This document is not an API Standard; it is under consideration within an API technical committee but has not received all approvals required to become an API Standard. It shall not be reproduced or circulated or quoted, in whole or in part, outside of API committee activities except with the approval of the Chairman of the committee having jurisdiction and staff of the API Standards Dept. Copyright API. All rights reserved.

Item 5401: Improve Clarity to section 2.7 in API RP 9B.

Figure XXX — Fleet Line Angle from Drum to Sheave and Sheave to Drum

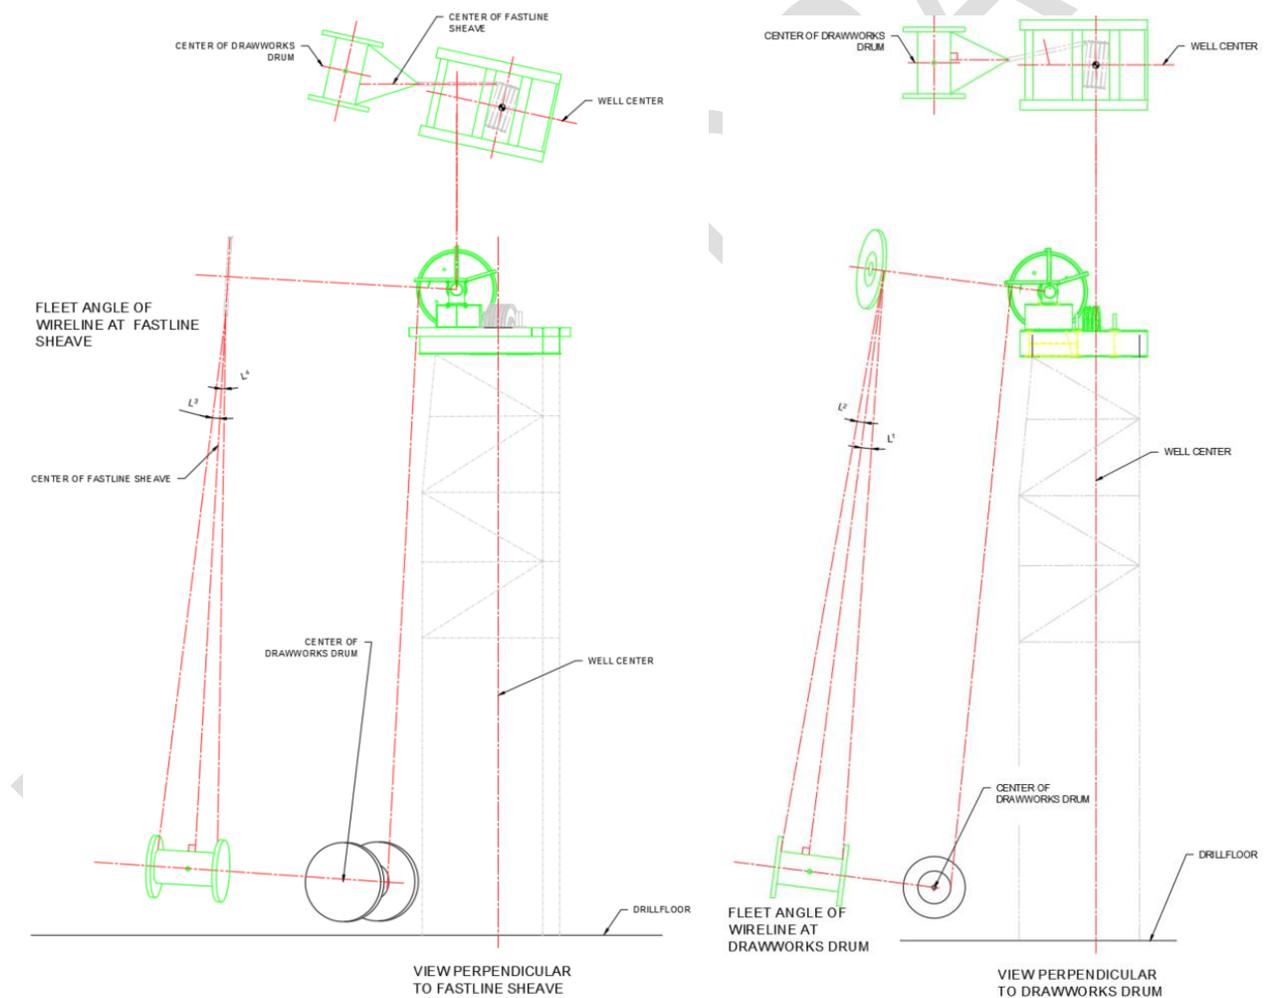
To check the fleet angle, Figure XXX can be referenced.

This figure shows the relationship between the critical dimensions used in calculating the fleet angle.
